RE: Adequacy Review 2 for 112 Construction Materials Reclamation Amendment 1 to the Permit,
Bernhardt Gravel Mine, Permit M-2002-120; Response

This letter is being generated to satisfy the preliminary review dated August 21, 2019 for the Bernhardt Gravel Mine. The italicized items are the current comment and the bold text are the responses:

EXISTING
CONDITIONS/
MINING
PLAN

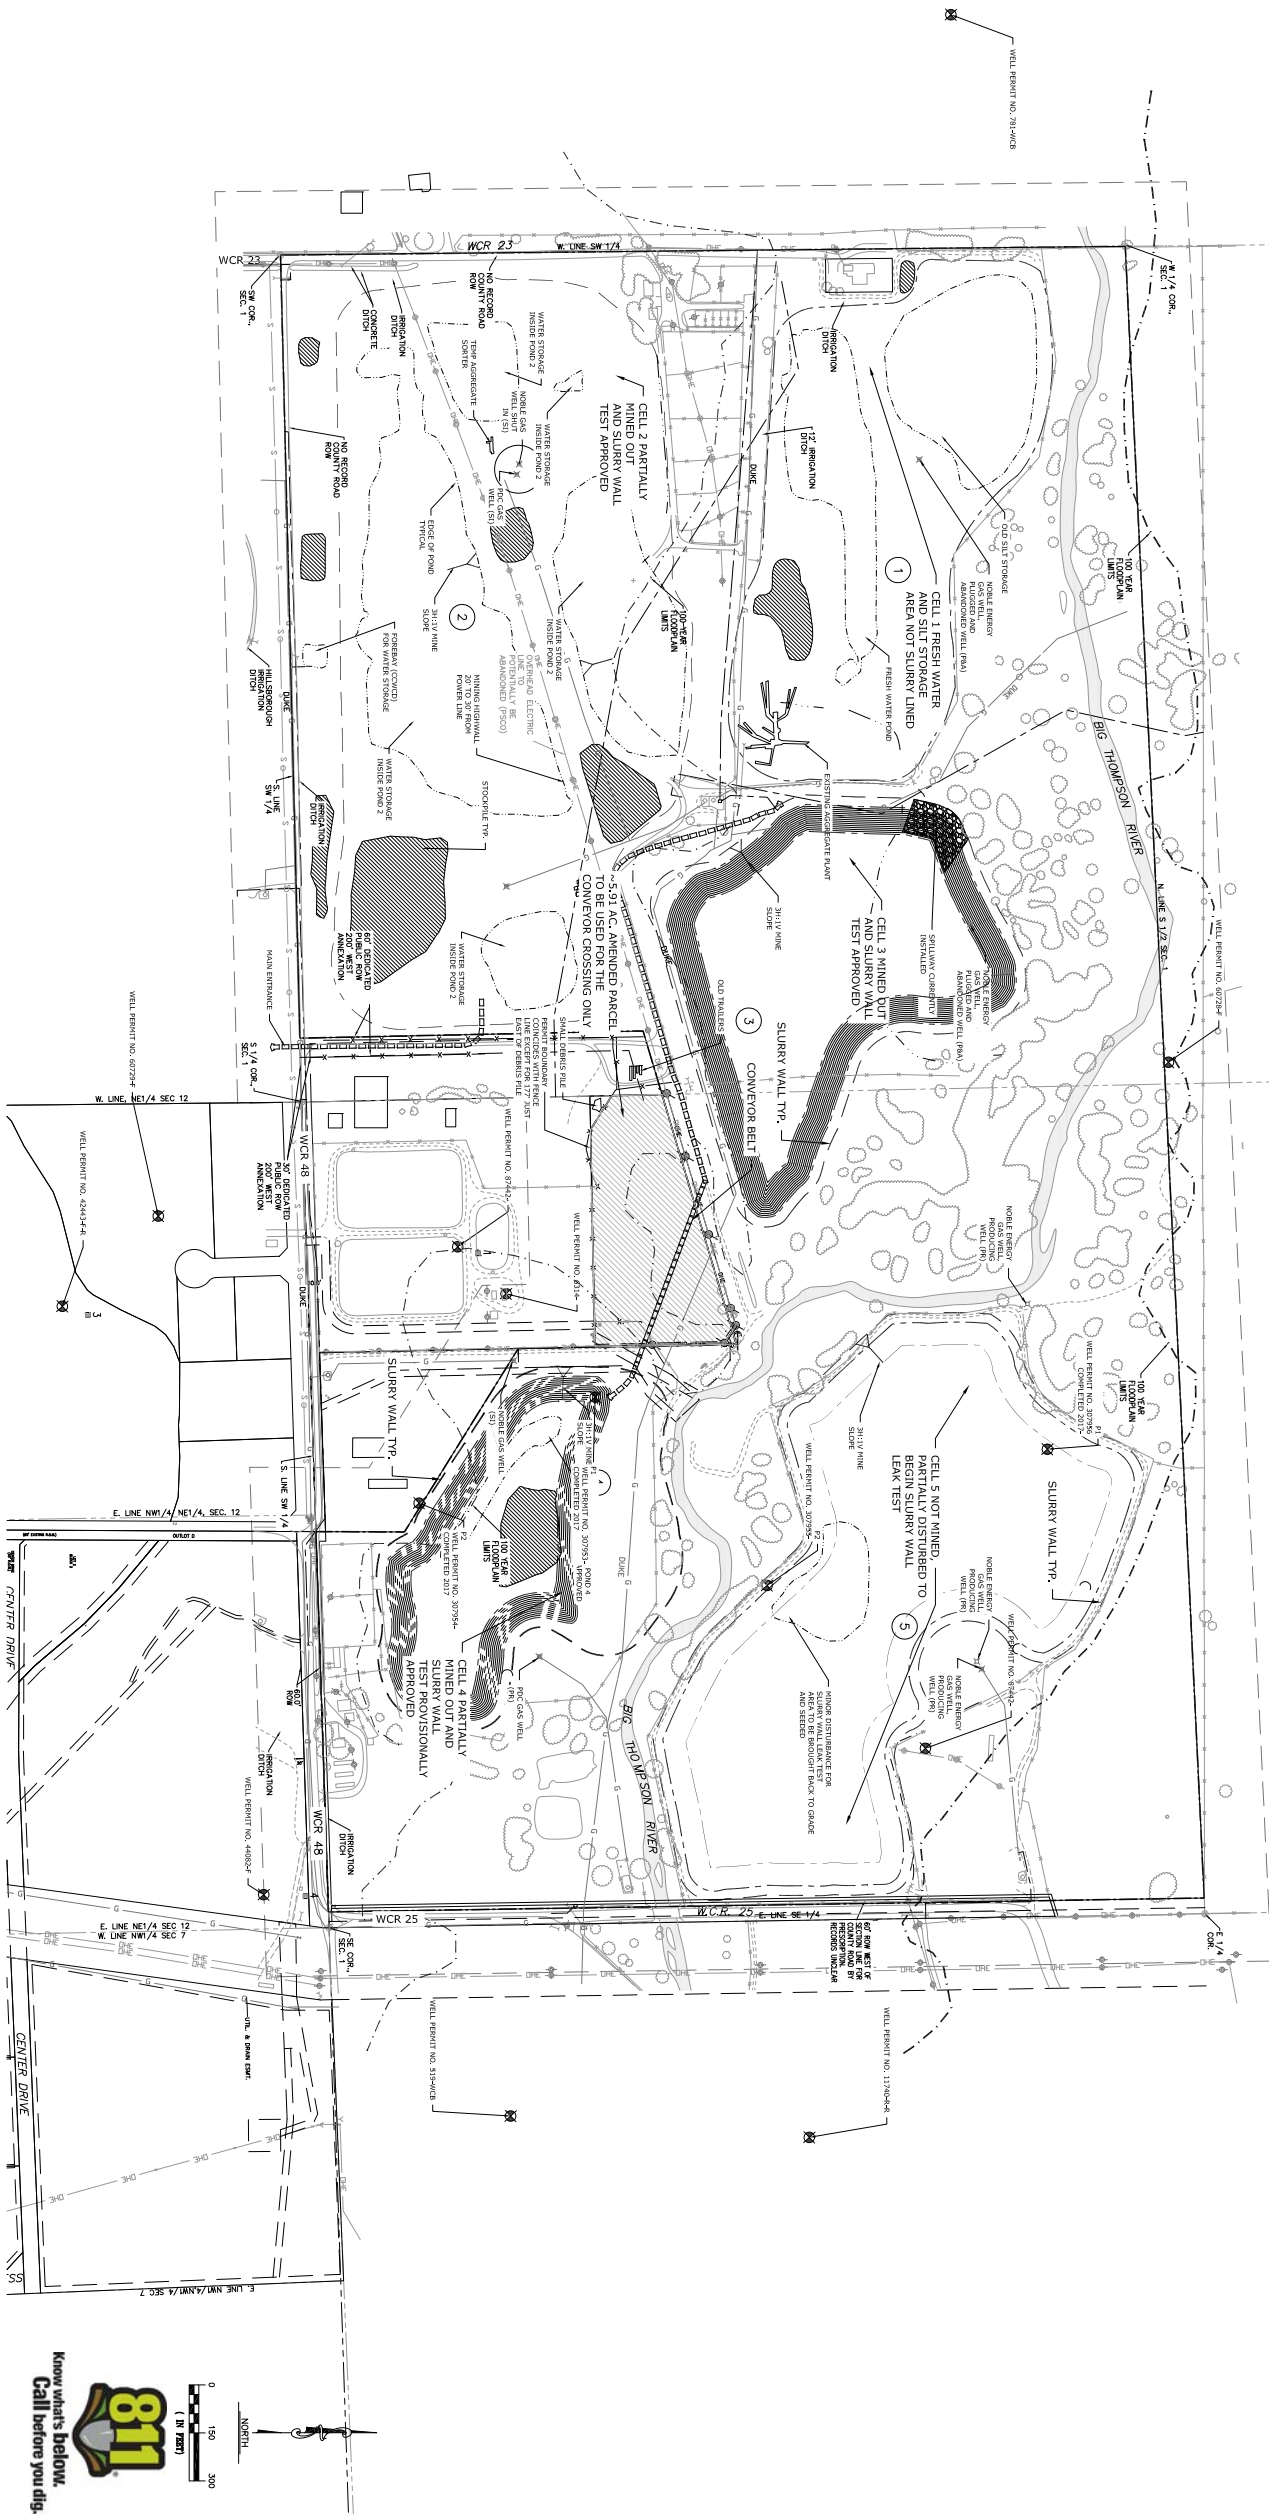
- *All maps will need to show the revised permit/amendment boundary that corresponds to the existing fence-line on the south side of the amended property, not the parcel boundary as currently shown. Please also include full size color copies of all final maps included in the application. **The maps and permit boundary have been updated. Full size maps have been include in the submittal.***

- *Please verify consistency in the mining and reclamation plans with respect to the statement that the amended parcel will not be mined. **The maps have been updated.***

STRUCTURES

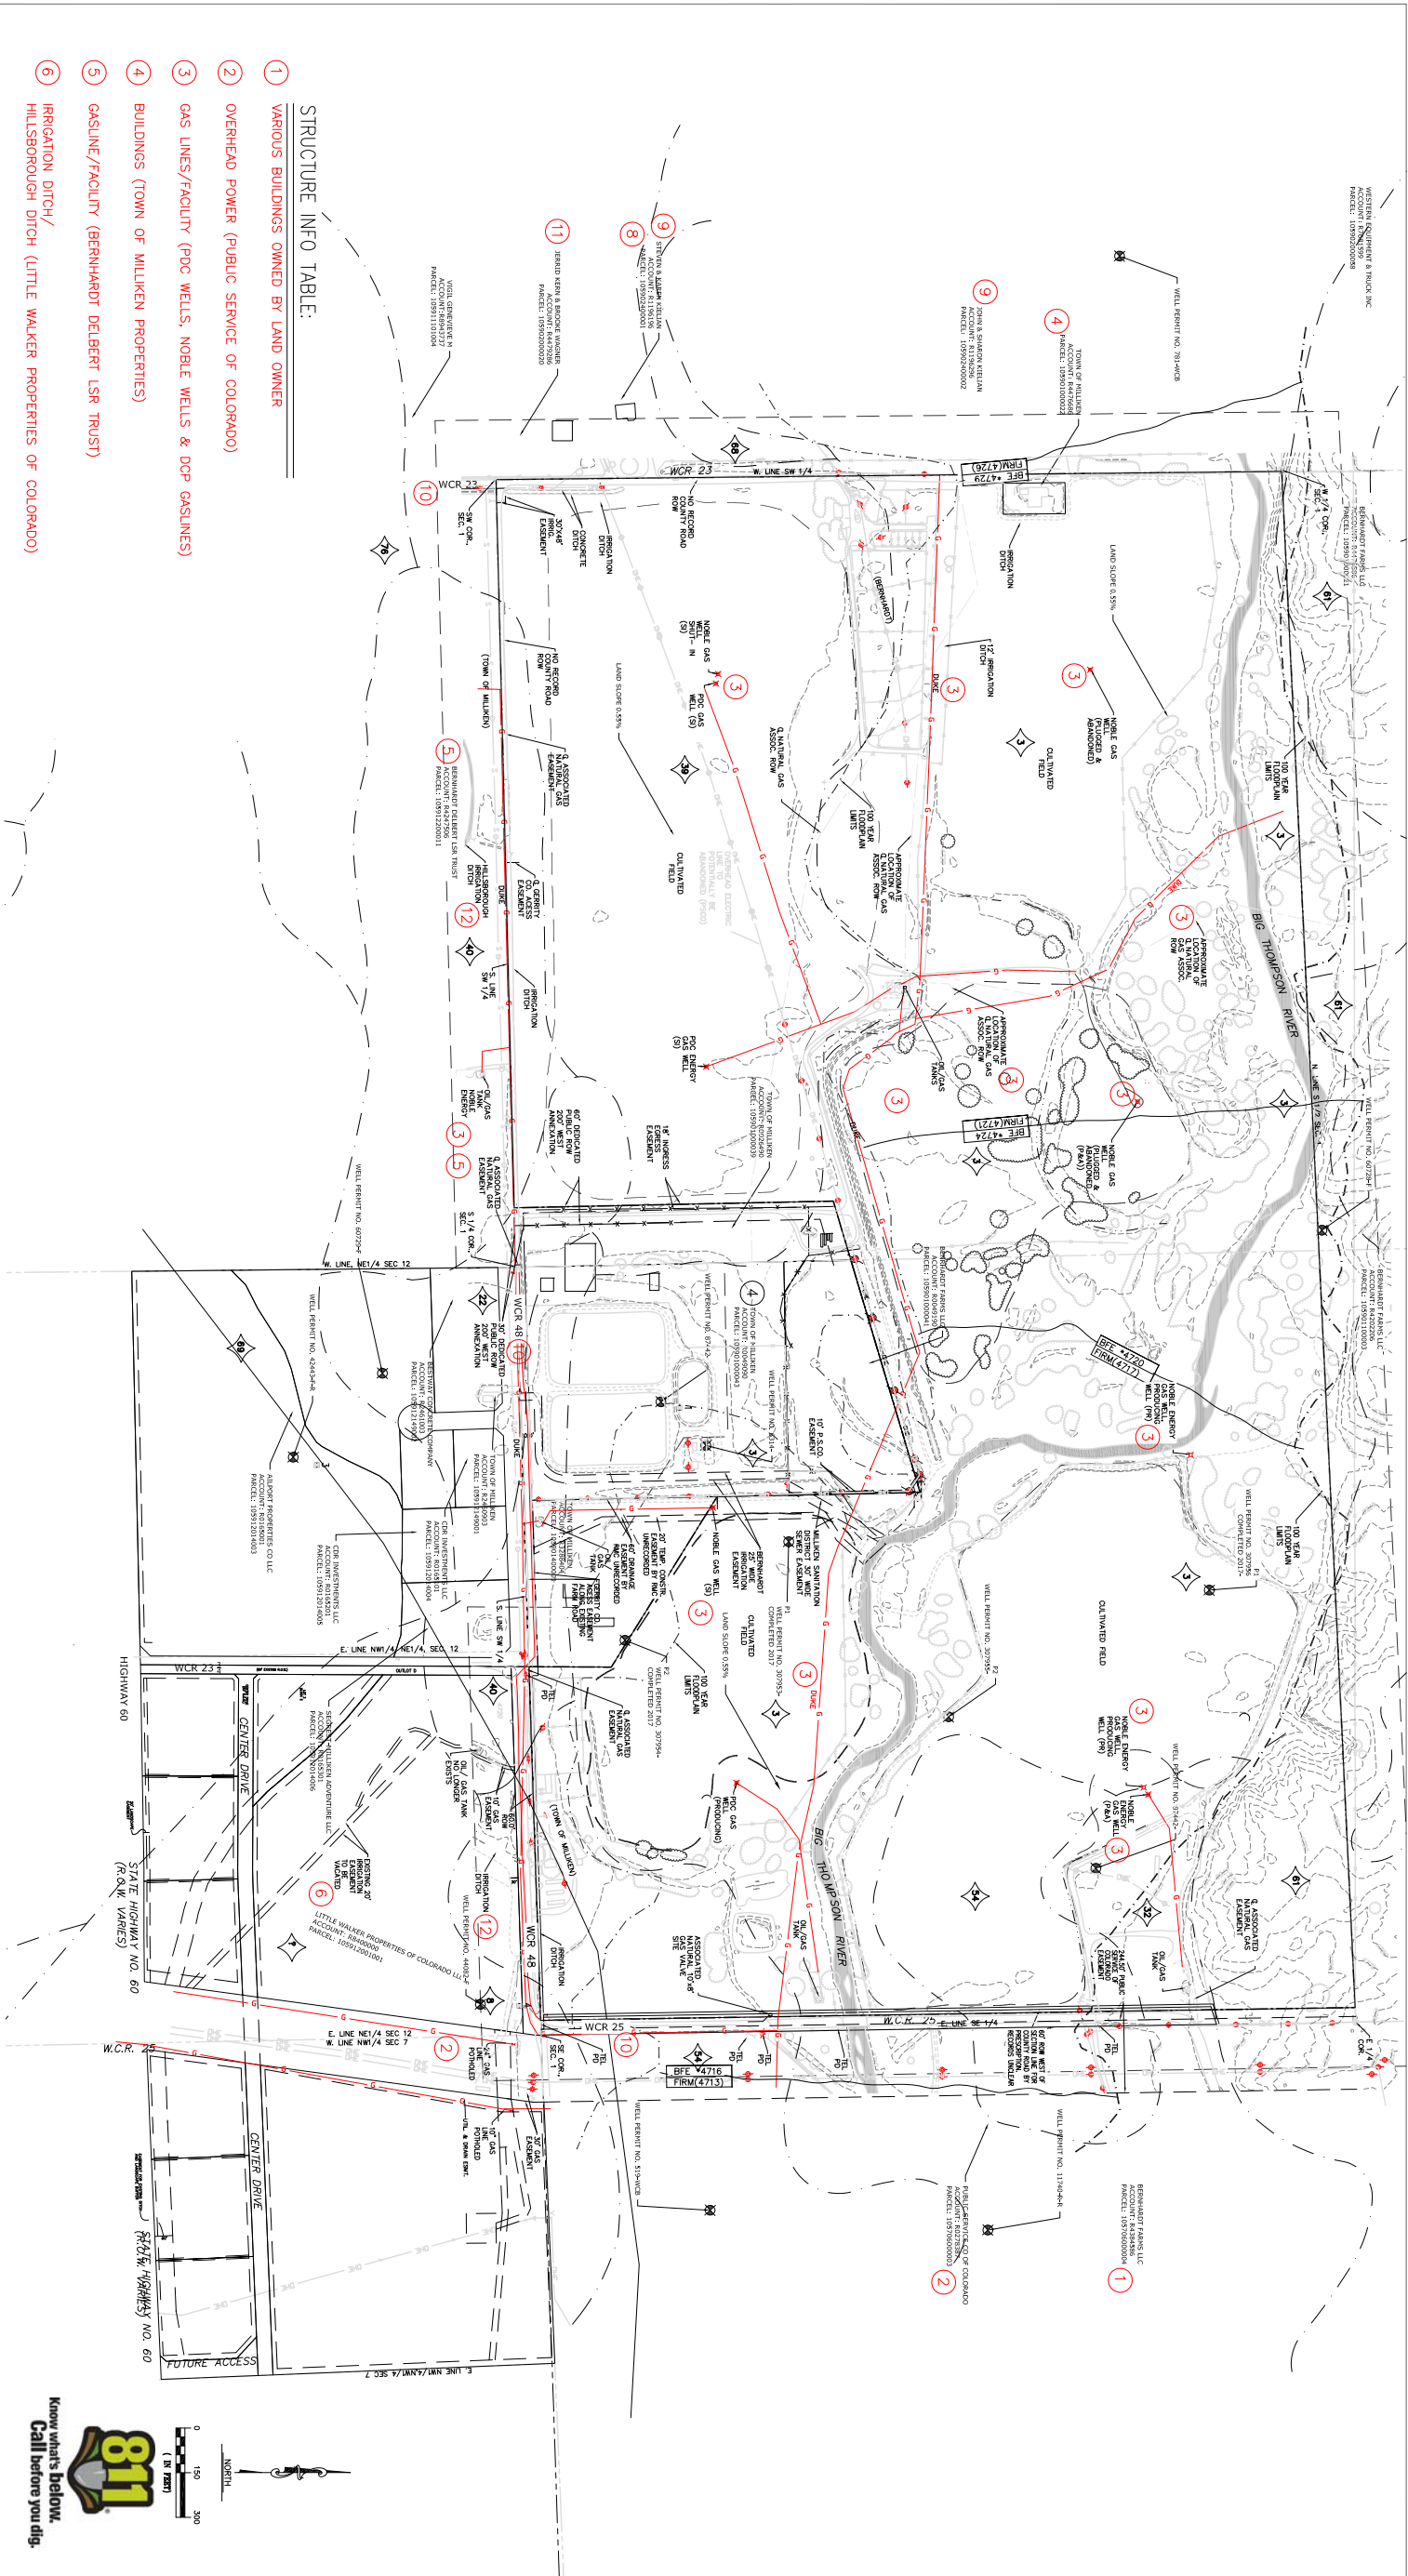
- *For Exhibit S, please provide a separate map and a table indicating where the structures are located within the permit and within 200' of the permit, and information showing who owns what structures, so that the provided structure agreement mailing information can be verified to be accurate and complete. A separate map and table have been included showing the structures. All signed structure agreements have been included.*

RECLAMATION
PLAN

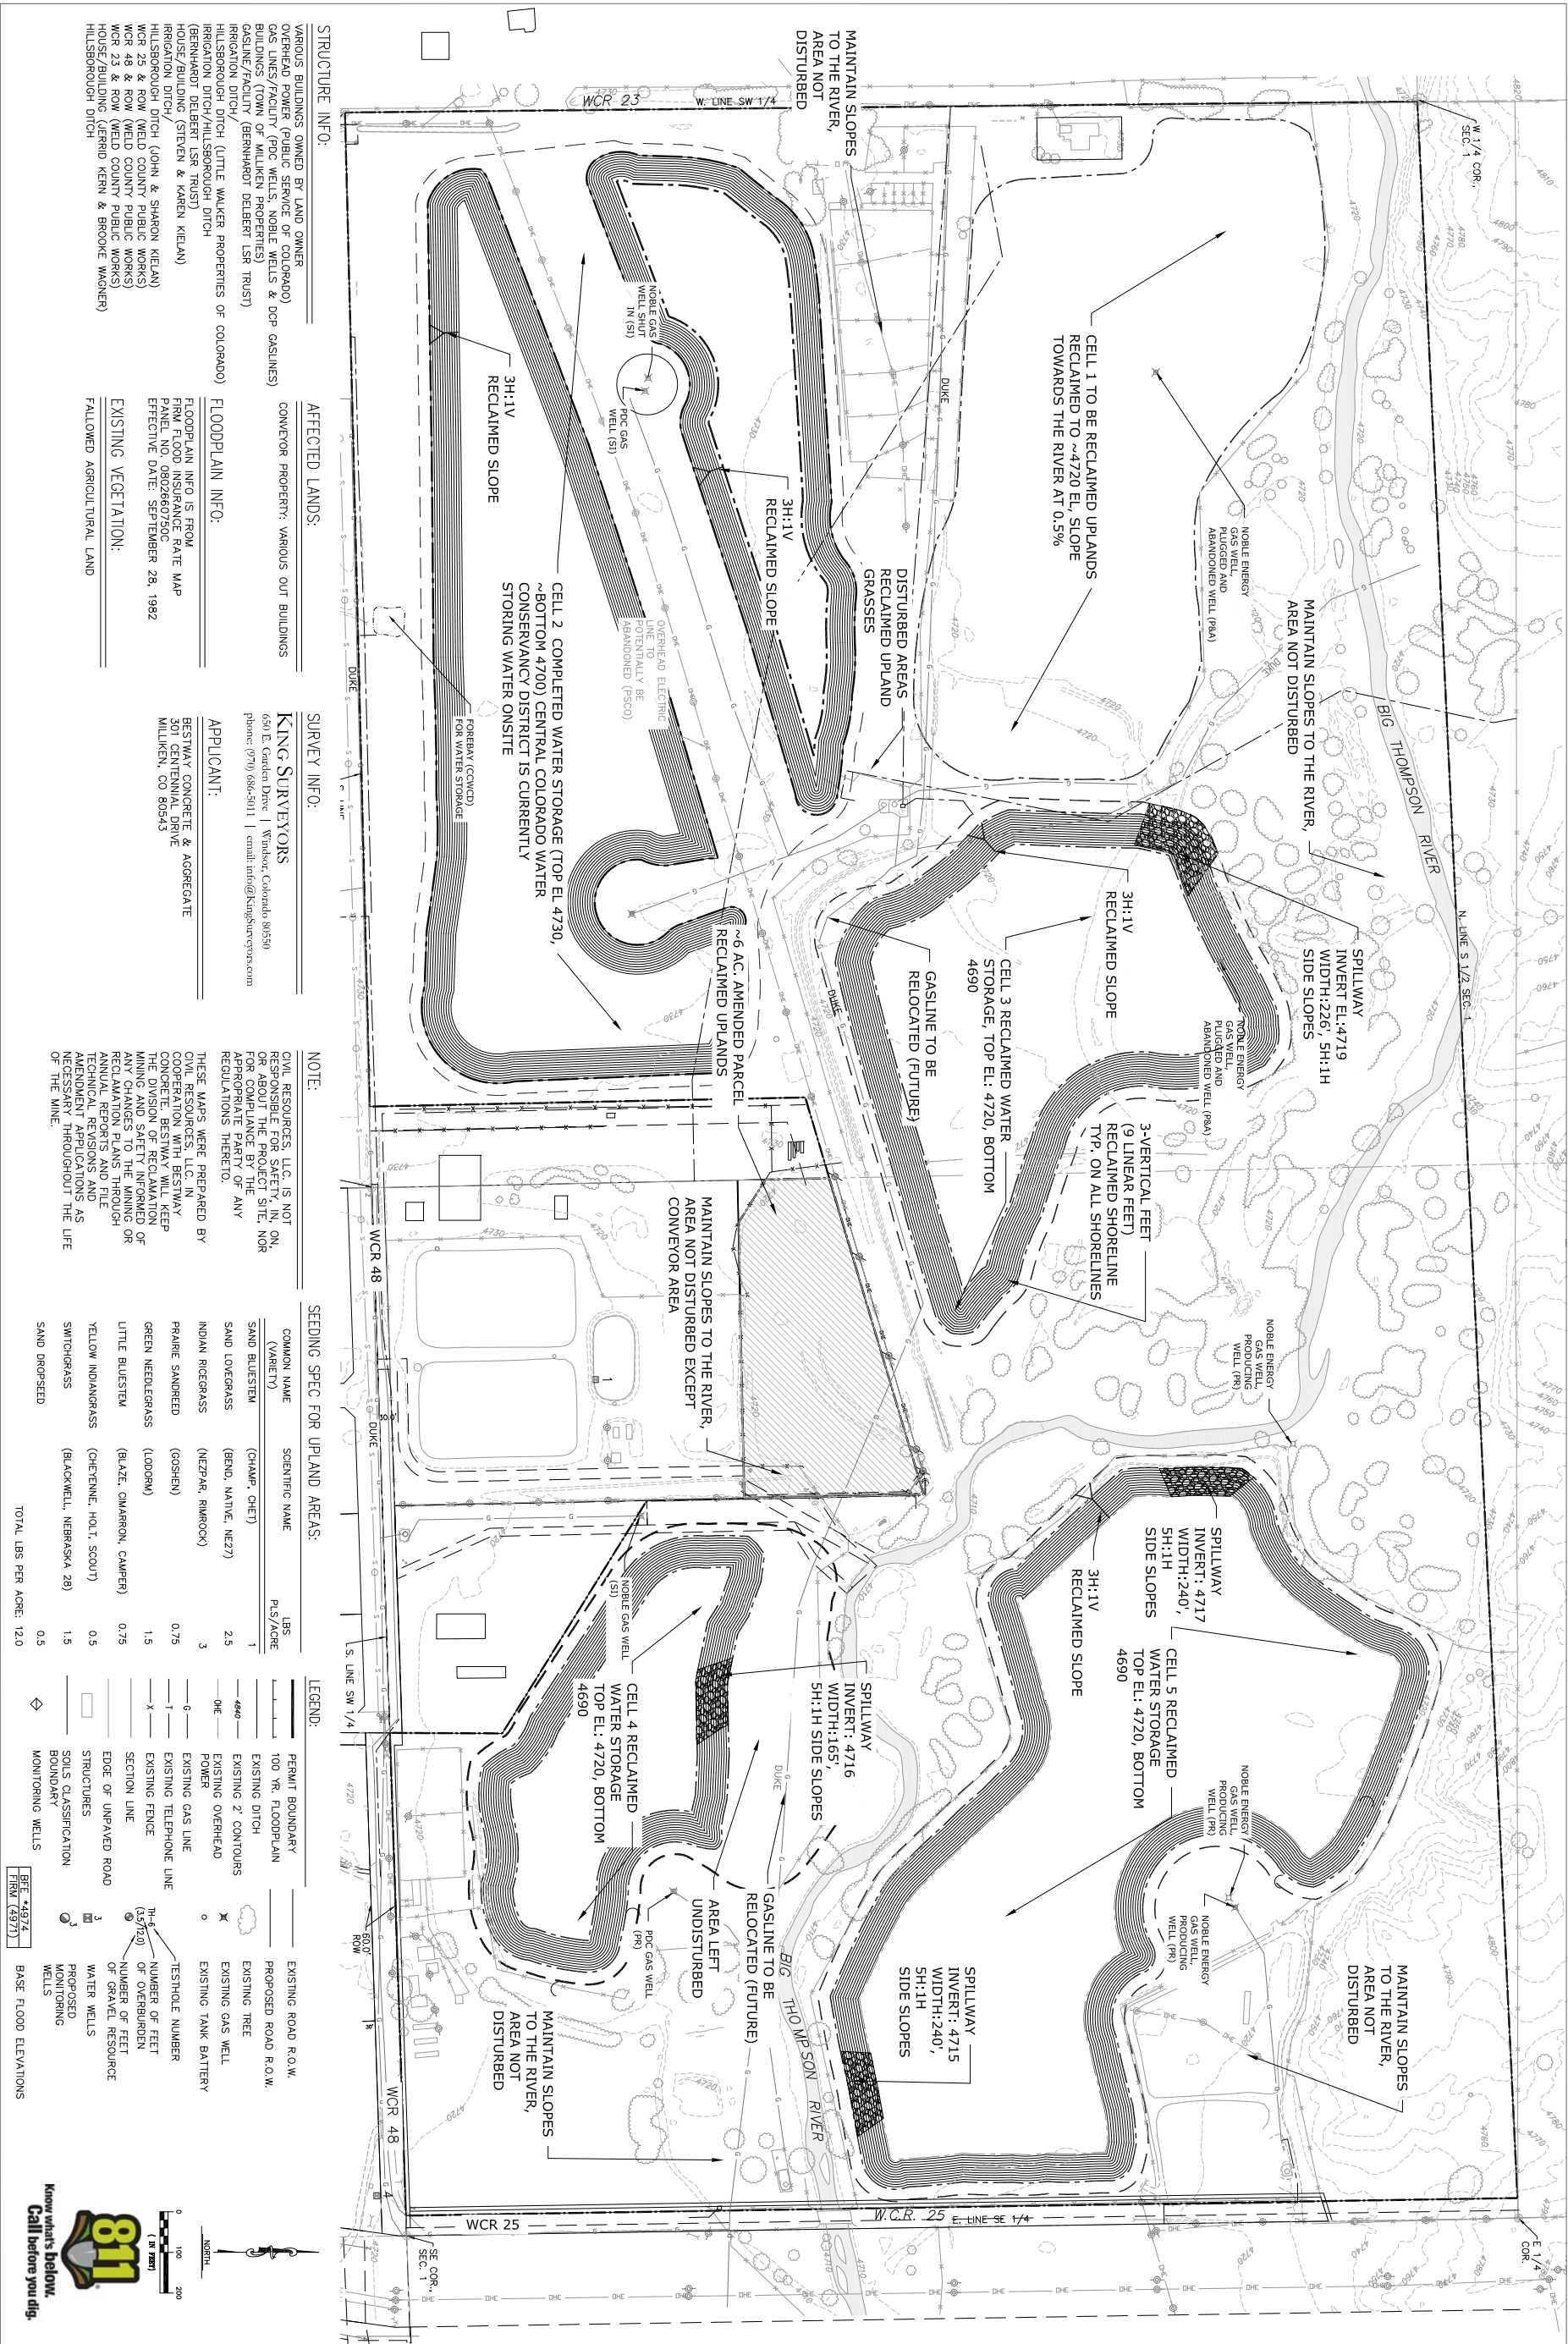
- *Please verify Exhibit F - Reclamation Plan Map to depict the proposed final shoreline configurations and setbacks for the reservoirs in Cells 2 and 3 with respect to the existing utilities (electric, gas, etc). The maps have been updated to depict the most recent configurations. Should a change in configuration occur a technical revision will be submitted to the DRMS.*

- *Please verify the proposed locations of all spillway inlet/outlet structures on the Exhibit Reclamation Plan Map. Some justification should be provided as to why only one inlet/outlet structure is believed to be sufficient for Cell 5. Given the configuration of the cell and proximity to the river, DRMS feels a reinforced outlet structure located near the southeast corner of the cell may also be required to prevent stream capture during a flood event. A spillway design memo has been attached discussing the spillways in more detail.*
